PROJECT MIDWAY So BAPTIST CHURCH  
 \_\_\_\_\_ JOB NO. \_\_\_\_\_  
 TO CHAS BREITENSTEIN  
 FROM A/B KLOOTEN  
 REFERENCE FINAL DRAINAGE PLAN

Re: S/D 81-100 - Final plat of Midway Southern Baptist Church Addition

Re: S/D 81-100 - Preliminary plat of Midway Southern Baptist Church  
Addition

PROJECT MIDWAY S. BAPTIST CHURCH ADD  
 \_\_\_\_\_ JOB NO. \_\_\_\_\_  
 TO CHRIS BREITENSTEIN  
 FROM N. BRENT HOOTEN  
 REFERENCE DRAINAGE CONCEPT.

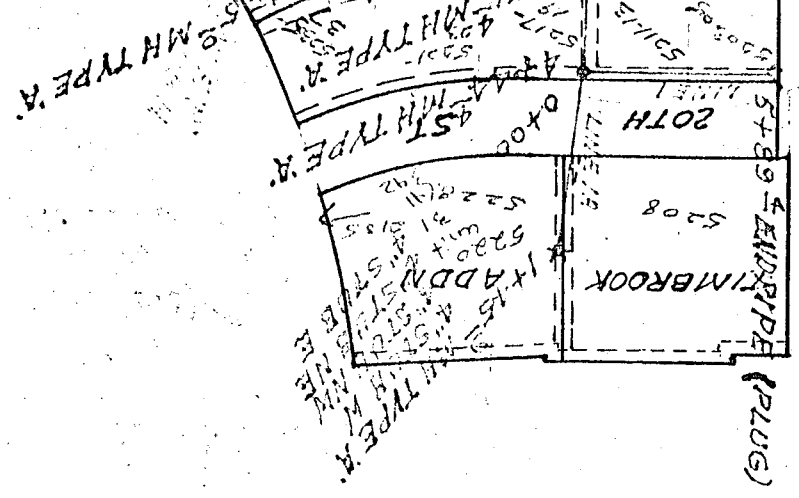
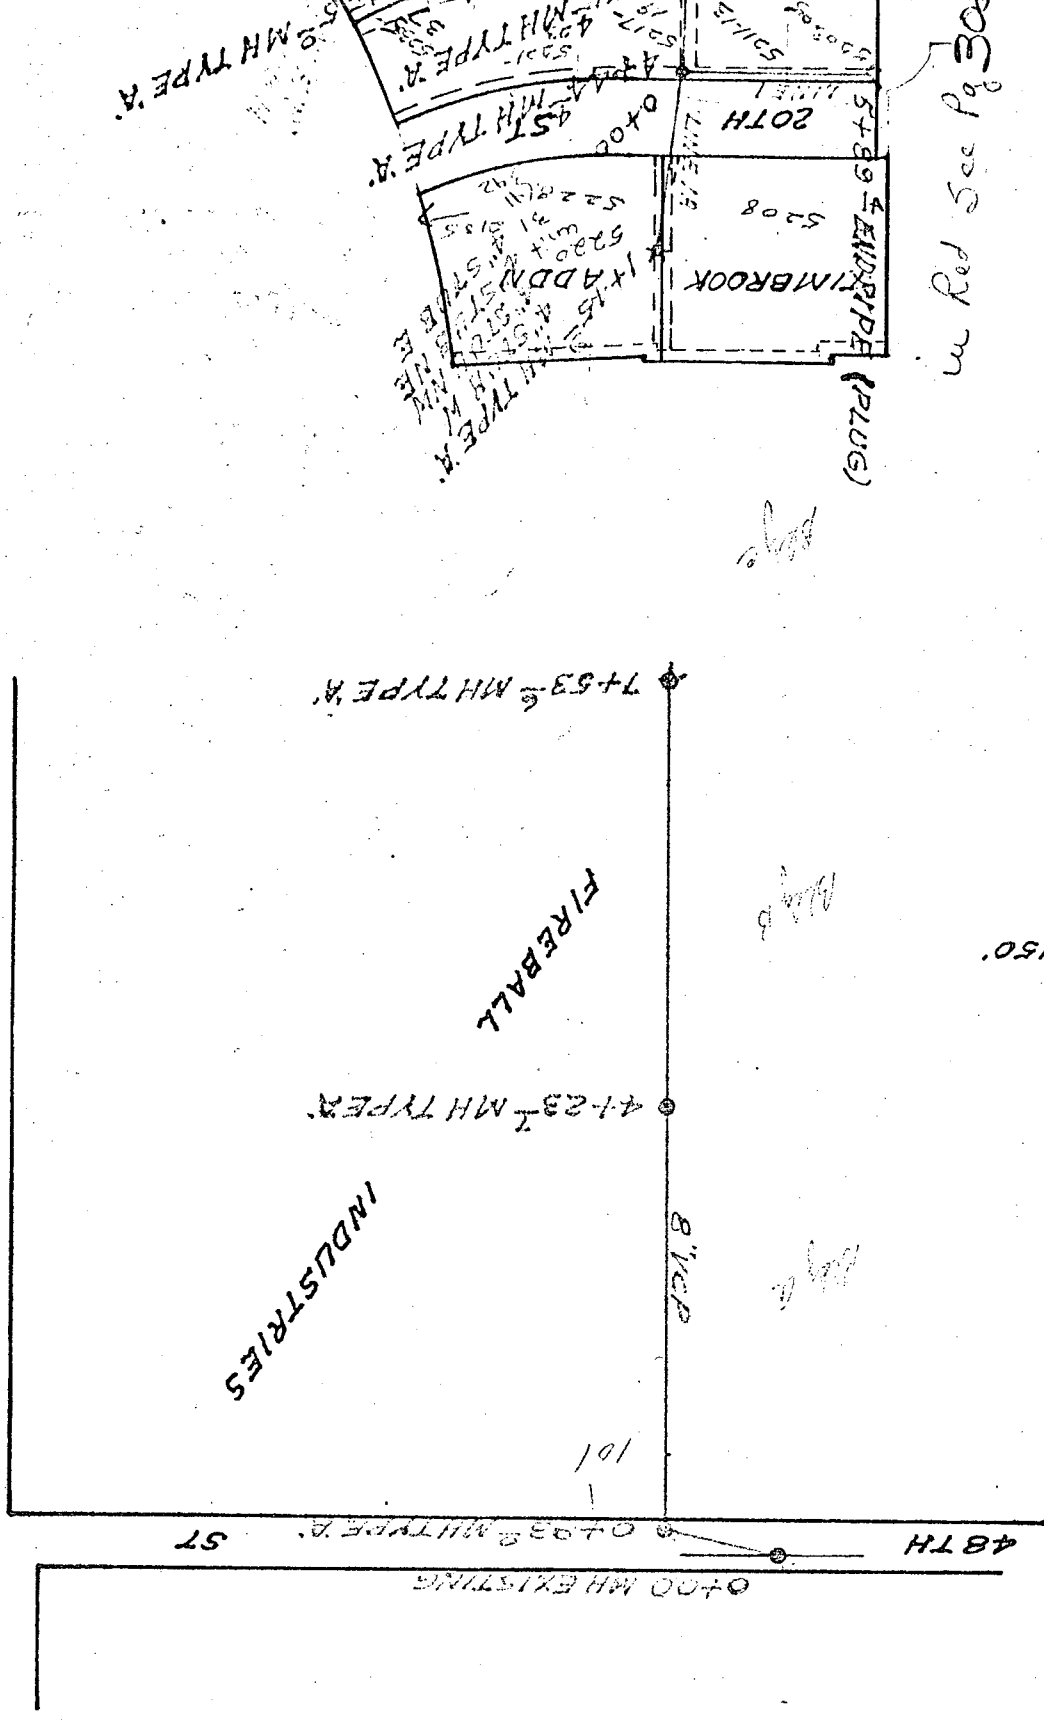
Enclosed herewith is the "marked" copy of the preliminary plat for your information and files.

in Red See Pg 30
